Brevard Final Remedial Investigation Report (RIR)

North Carolina Department of Environmental Quality (DEQ) Comments and DuPont Responses

Re: **Comments on Remedial Investigation Report**
Former DuPont Brevard Facility
EPA ID No. NCD 003 152 329

Re: Response to NCDEQ Comments on the Remedial Investigation Report
Former DuPont Brevard Facility
Cedar Mountain, North Carolina
NCDEQ RCRA Permit No. NCD 003 152 329

Figure 1

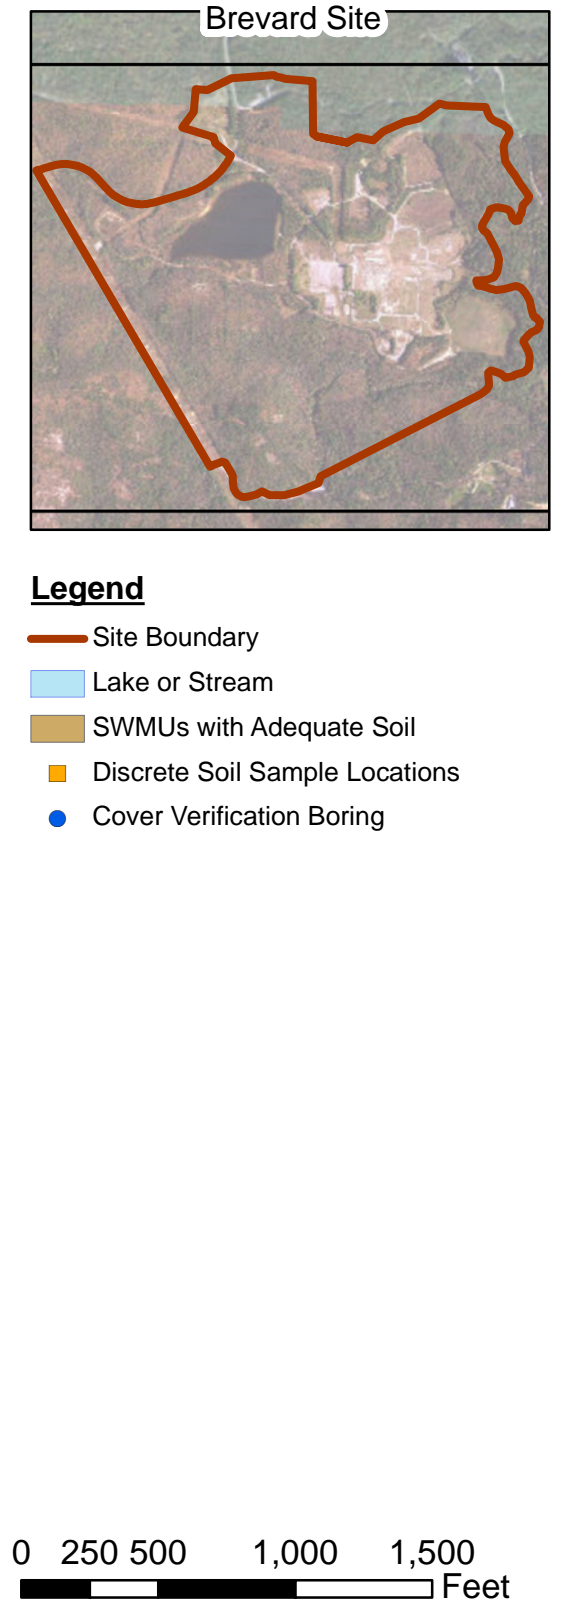
| NCDEQ Comment | DuPont Response |
|---|---|
| <p>1. DuPont should install a minimum of two (2) monitoring wells just east of the DuPont State Forest (DSF) Visitor Center. One of the wells should be screened across the water table. Another well should be screened at the top of bedrock. If bedrock is encountered prior to encountering the water table, DuPont should attempt to screen a well(s) at the first water bearing fracture encountered in bedrock. The purpose of these wells is to help determine the extent of groundwater contamination north of Solid Waste Management Unit (SWMU) 17.</p> | <p>DuPont does not believe conducting additional groundwater monitoring east of the DuPont State Recreational Forest (DSRF) Visitor Center is warranted. Based on the future land use plans provided by the State of North Carolina (State), surficial aquifer (shallow) groundwater (i.e., 13 to 78 feet below ground surface [bgs]) will not be used in the future. The only structures in this area (a public restroom and the Aleen Steinberg Center) are serviced with potable water from a nearby bedrock aquifer “deep well” (see Figure 1). Possible impacts to groundwater from SWMU 17 are removed prior to use by a granulated activated carbon treatment system installed and maintained by DuPont at the Aleen Steinberg Center. Surface water samples collected from seeps located downgradient of SWMU 17 did not indicate any adverse impacts (Parsons 2009).¹</p> <p>During DuPont’s discussions with NCDEQ during a December 2, 2015 meeting, it became apparent that NCDEQ is concerned with the potential for vapor intrusion into the Aleen Steinberg Center. Although vapor intrusion was not of concern from potentially contaminated shallow groundwater based on the results of soil gas samples collected around the Aleen Steinberg Center, and future land use plans provided by the State indicate that no new buildings will be constructed in this area, DuPont understands this concern and will work with NCDEQ to create a scope of work (SOW) to address this issue including the installation of a sentinel well near the visitors center.</p> <p>In addition, DuPont is proposing to address the suspected contaminant source area at SWMU 17 through in-situ treatment remedial actions.</p> |

Figure 2

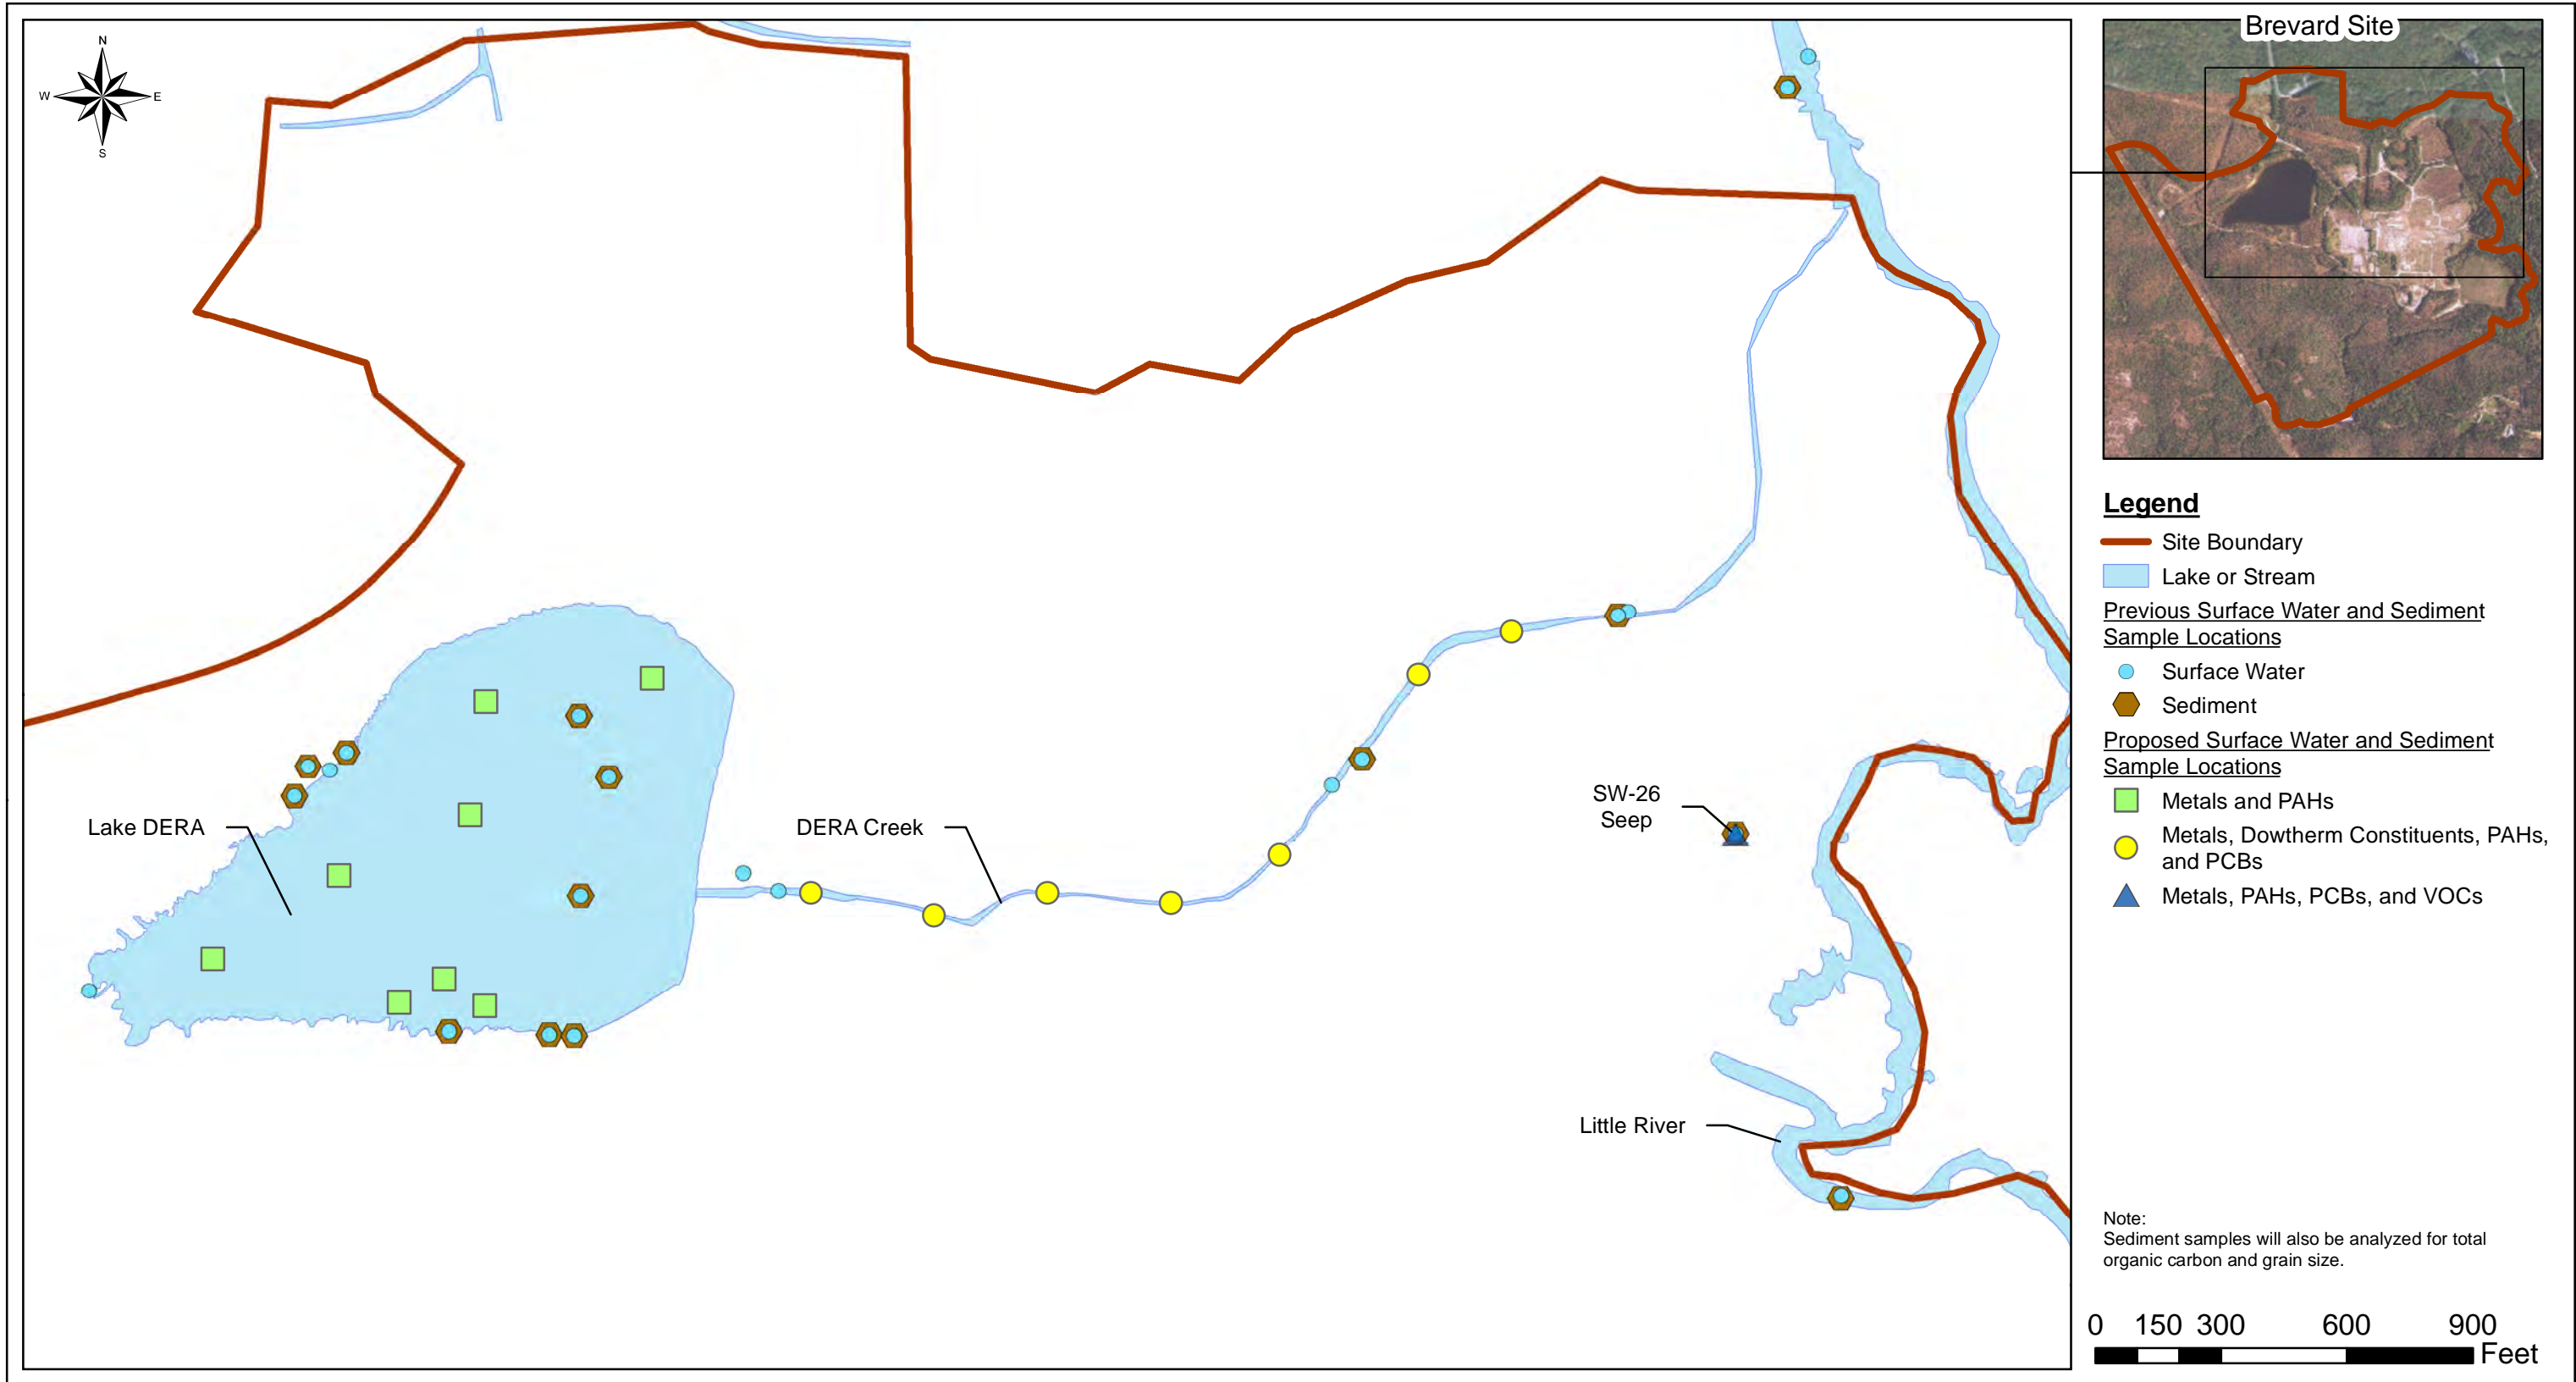
| NCDEQ Comment | DuPont Response |
|---|---|
| <p>2. Due to occasional detections of contaminants in samples collected from DERA Creek during historical surface water monitoring, DuPont should develop a surface water monitoring plan to collect samples quarterly for a one year period from DERA Creek. Due to the detection of contaminants above NC 2B standards, the monitoring plan should include sample collection from the seep area downgradient of the former WWTP polishing pond. The monitoring plan should include at least one sampling event during a period when surface water flow is typically at lower flow conditions based on historical information. In addition, as stated in Comment 12 of the September 25, 2014 letter from the HWS to DuPont, if Polycyclic Aromatic Hydrocarbons (PAHs) were detected in sediment samples collected during the RI, analysis of surface water for the presence of PAHs may be required. Since PAHs were detected in DERA Creek sediment, PAHs should be added to the list of analytes for surface water</p> | <p>Surface water sample concentrations collected during the Remedial Investigation were less than NC 2B standards (human health or aquatic life) and Ecological Screening Values (ESVs) with the following exceptions (see Section 5.3 of the RIR).</p> <ul style="list-style-type: none"> • Iron concentrations in DERA Creek exceeded the NC 2B standard (aquatic life) in one location (SW-8); however, no exceedances were observed in locations sampled further downstream prior to DERA Creek’s confluence with Little River. • Manganese concentrations were above the ESV in all locations in DERA Creek. Iron concentrations exceeded the NC 2B standard (aquatic life) in the SWMU 14 drainage ditch (ball field sample). • Vinyl chloride and iron concentrations exceeded the NC 2B standard and manganese exceeded the ESV in seep location SW-26. <p>Based on these results, the potential for adverse ecological effects from Site surface</p> |

| NCDEQ Comment | DuPont Response |
|---|---|
| <p>samples collected during these quarterly monitoring events.</p> | <p>water is limited. In addition, surface water flow in DERA Creek originates from Lake DERA and is controlled by a weir. Therefore, the flow is not seasonal in nature.</p> <p>To confirm that the potential for adverse ecological effects from Site surface water is limited, DuPont will collect one round of surface water and co-located sediment samples to complete the characterization of surface water and sediment. The proposed sample locations are presented on Figure 2. The samples will be analyzed as follows:</p> <ul style="list-style-type: none"> • The Lake DERA samples will be analyzed for metals and PAHs² • The DERA Creek samples will be analyzed for metals, PAHs, and PCBs. All PCB samples will be analyzed for Aroclors and 10% of samples will be analyzed for congeners. The samples that will undergo congener analysis will be determined once the Aroclor analyses are complete. • The seep sample will be analyzed for metals, PAHs, PCBs (Aroclors), and VOCs |

| NCDEQ Comment | DuPont Response |
|--|--|
| <p>7. In Section 7.7. and Table 25, DuPont summed the concentration of individual PAHs and then used this total number when determining the Hazard Quotient (HQ) for PAHs in sediment. DuPont should determine the HQ for each individual PAH separately. In addition, as part of the ecological evaluation process, DuPont used averages of constituent concentrations in sediment sampled from Lake DERA, DERA Creek, and the Little River to screen contaminants. Due to the distance between sampling locations and differences in sample environments, DuPont should not use the average value from all of these areas in the screening process. Reevaluating the data using individual PAHs and not using the averaged values indicates additional sediment sampling is necessary to fully evaluate the ecological risk in DERA Creek and Lake DERA. DuPont should develop a sediment sampling plan to fully evaluate the ecological risk from contaminated sediments.</p> <p>In addition, Polychlorinated Biphenyls (PCBs) were detected during soil sampling at the Facility. Although EPA Region 4 is overseeing Corrective Action related to the PCB contamination, comment 12 of the September 24, 2014 letter from the HWS to DuPont states that analysis of sediment samples for the presence of PCBs may be required if PCBs were detected in soil samples collected during the RI. DuPont may want to include PCB analysis in the next round of sediment sampling to prevent having to return to the site for additional sediment sample collection potentially requested by EPA.</p> | <p>DuPont will collect one round of surface water and co-located sediment samples to complete the characterization of surface water and sediment. The proposed sample locations are presented on Figure 2. The samples will be analyzed as follows:</p> <ul style="list-style-type: none"> • The Lake DERA samples will be analyzed for metals and PAHs³ • The DERA Creek samples will be analyzed for metals, PAHs, and PCBs. All PCB samples will be analyzed for Aroclors and 10% of samples will be analyzed for congeners. The samples that will undergo congener analysis will be determined once the aroclor analyses are complete. • The seep sample will be analyzed for metals, PAHs, PCBs, and VOCs |
| <p>8. The RIR indicates surface water samples were collected at or just below the surface of Lake DERA. The RIR also indicates contamination was detected above residential standards in several sediment samples and above industrial standards in one sediment sample collected from Lake DERA. Although the likelihood of an individual coming into significant contact with sediment is minimal, DuPont should collect surface water samples from the water column just above the bottom of Lake DERA in the area(s) of sediment contamination and should collect additional sediment samples from Lake DERA to fully evaluate the ecological risk in Lake DERA. DuPont should also consider the potential effect sediment contamination would have on fish populations in Lake DERA and whether tissue samples are appropriate to fully evaluate risk to</p> | <p>The potential risks to fish⁴ and recreators being exposed to Lake DERA sediment were evaluated by comparing average sediment constituent concentrations in Lake DERA to ecological screening values (ESVs) or background concentrations and trail user human health screening levels (see Table 1). Only three PAH constituent concentrations exceeded ESV or background criteria and the maximum exceedance was only two times the criterion. Thus the potential risk to fish in Lake DERA is low and does not warrant further evaluation (tissue sampling). In addition, the average sediment constituent concentrations were all less than the Trail User remedial levels (RL) indicating that the potential risk to future recreators is low.⁵ However, additional sediment and co-located surface water samples are proposed in Lake DERA to characterize metal and PAH concentrations (see Figure 1). Surface water</p> |

| NCDEQ Comment | DuPont Response |
|---|--|
| potential receptors. | samples will be collected just above the bottom of Lake DERA. |
